PLANNING COMMISSION STAFF REPORT

Mt. Olivet/Roland Hall-St. Mark's School Subdivision
Petition PLNSUB2010-00692
1443 East Sunnyside Avenue

December 8, 2010

**Exhibit A –
Site Plan**

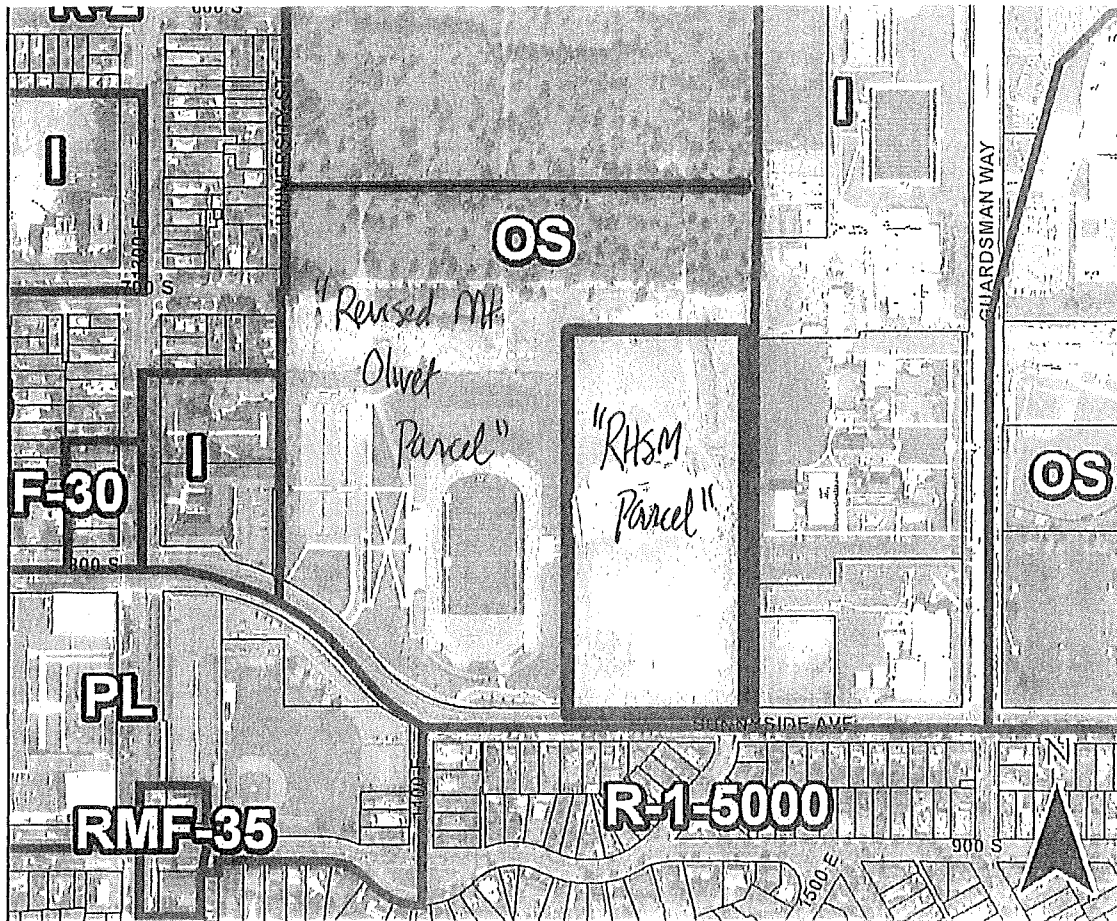
| Date | Task/Inspection | Status/Result | Action By | Comments |
|------------|----------------------|---------------|-----------------|--|
| 10/29/2010 | Engineering Review | Complete | Drummond, Randy | <p>TO: LEX TRAUGHER, SENIOR PLANNER, PLANNING DIVISION FROM: RANDY DRUMMOND, P.E., ENGINEERING DATE: OCT. 29, 2010</p> <p>SUBJECT: # PLNSUB2010-00692 Mt. Olivet Cemetery Minor Subdivision 1433 East Sunnyside Avenue Minor Subdivision Review</p> <p>Engineering review comments are as follows:</p> <p>This submission consists of one existing 41.5 acre parcel, with a track facility, cemetery, and vacant area, which is proposed to be divided into two parcels. One of the parcels will be 28.446 acres in area with the cemetery and track facility, and the other parcel will contain the vacant land of 13.087 acres, to be used by the Rowland Hall-St. Mark's School. Both Sunnyside Avenue and 1300 East are fully dedicated and improved with curb, gutter, sidewalk and asphalt pavement. On Sunnyside Avenue the sidewalk abuts the back of curb, and along a majority of the frontage the front of the sidewalk has settled below the top back of curb elevation. We suggest the applicant may wish to replace the sidewalk along the frontage where this has occurred. If the applicant wishes to do so, a Public Way Permit must be obtained from our office by a licensed, bonded and insured contractor before said work can proceed.</p> <p>We understand that no plat is required for this project.</p> <p>cc: Scott Weiler Brad Stewart Barry Walsh Craig Smith George Ott Vault</p> |

| 11/4/2010 | Transporation Review | Complete | Walsh, Barry | <p>November 4, 2010</p> <p>Lex Traughber, Planning</p> <p>Re: PLNSUB2010-00692 Mt. Olivet Subdivision Preliminary Plat a t 1443 East Sunnyside Avenue.</p> <p>The division of transportation review comments and recommendations are as follows:</p> <p>The proposed subdivision to create two lots both have frontage on a public right of way, Sunnyside avenue with existing roadway improvements consisting of paved roadway, curb & gutter, pedestrian sidewalk, street lighting, and utilities. Per our past review comments we require engineering and utility review comments for any required upgrades or repairs as needed.</p> <p>Sincerely,</p> <p>Barry Walsh</p> <p>Cc Kevin Young, P.E. Randy Drummond, P.E. Peggy Garcia, Public Utilities Ted Itchon, Fire Larry Butcher, Permits File</p> |
| 11/9/2010 | Public Utility Review | Complete | Stoker, Justin | <p>Public Utilities has no objection to the proposal. The subdivision does not impact any known utility lines public or private. The proposed RHSM parcel does not have any current water or sewer connections and can be subdivided off without problems. Note that private utilities may not cross property lines. If this lot is to be used in the future by Rowland Hall - St Mark's School, it will need its own utility services or go through another subdivsion process to combine the lot with the existing RHSM lot located to the east.</p> |
